MARK	DATE	DESCRIPTIONS	BY	CH'D	CCO#
0	03/08/10	MEP INTEGRATION	JE	FW	110

CONTRACT CHANGE ORDER NO._____
SHEET _____ OF _____

DETAILS
SCADA REMOTE TERMINAL UNIT SYSTEM
RTU #13W AND #13E ASSEMBLY
NO SCALE

E-910

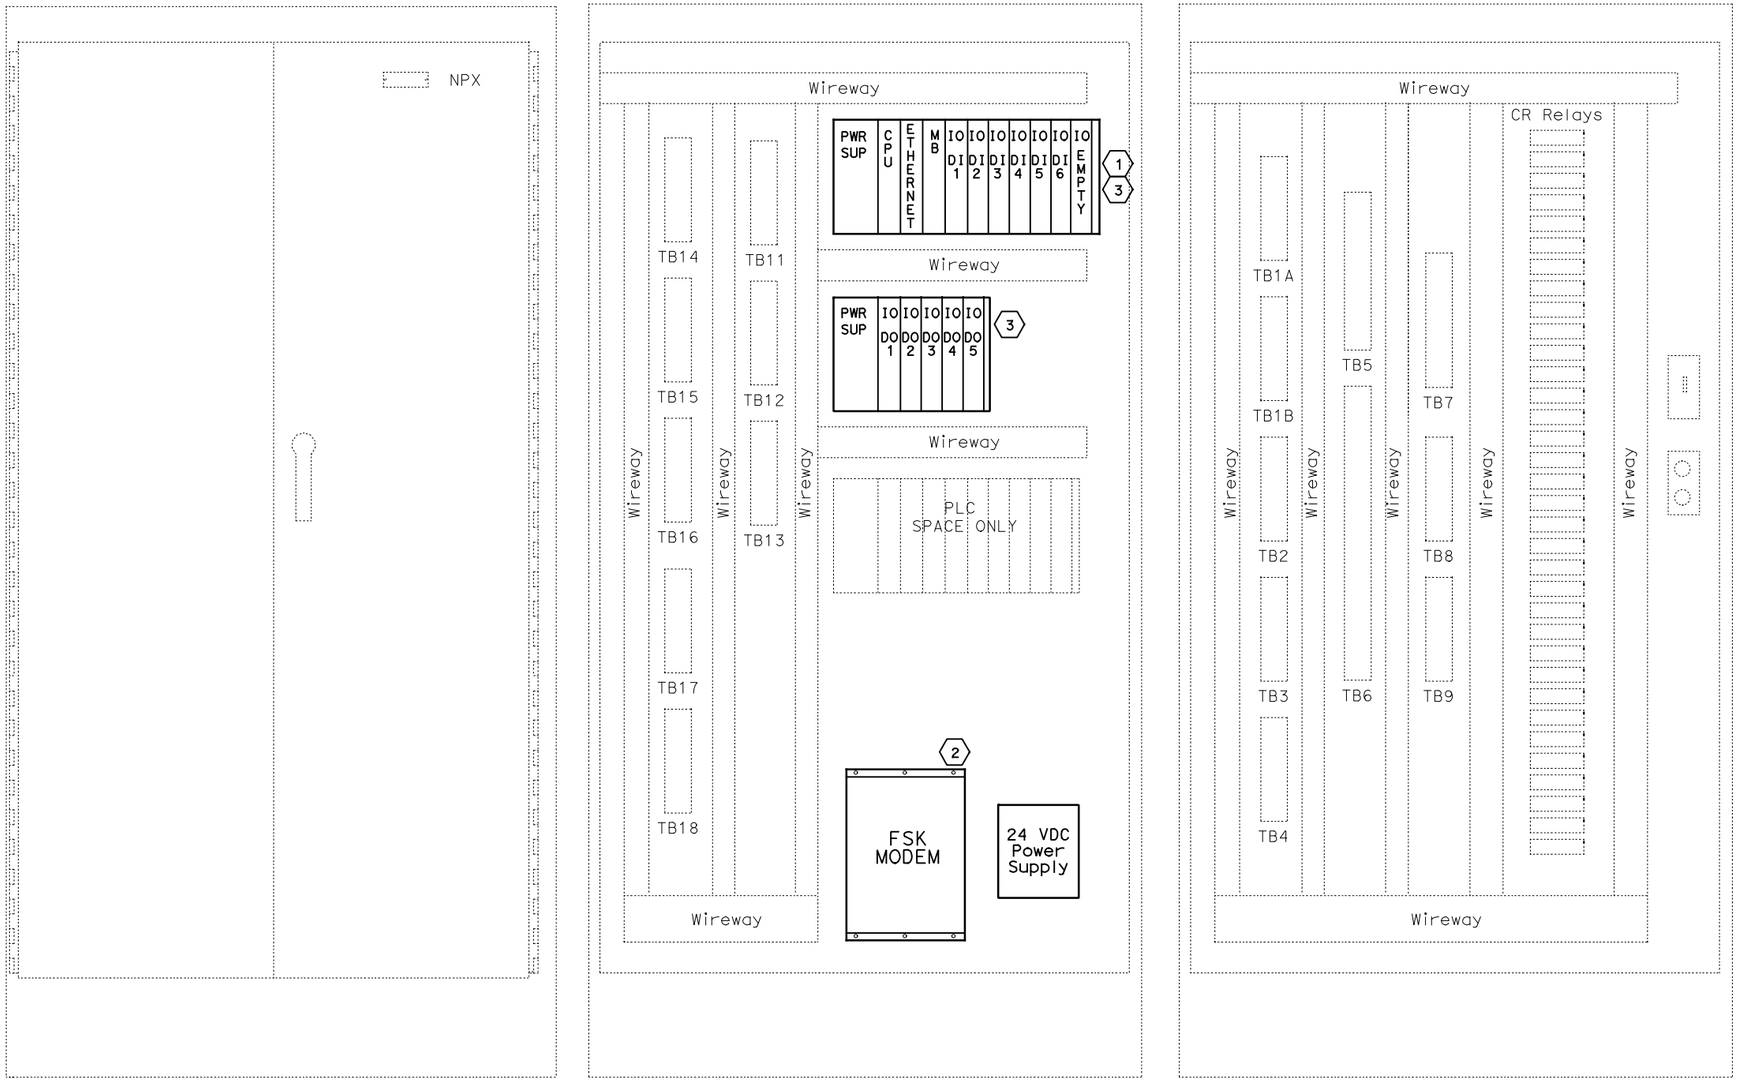
(1) Contractor shall furnish and install a new GE Fanuc PAC Systems RX3i PLC in the existing RTU.

(2) Contractor shall furnish and install a new Frequency Shift Key (FSK) modem and 120v (AC) to 21v-28v (DC) power supply in the existing RTU.

(3) Contractor shall install the input and output cards.
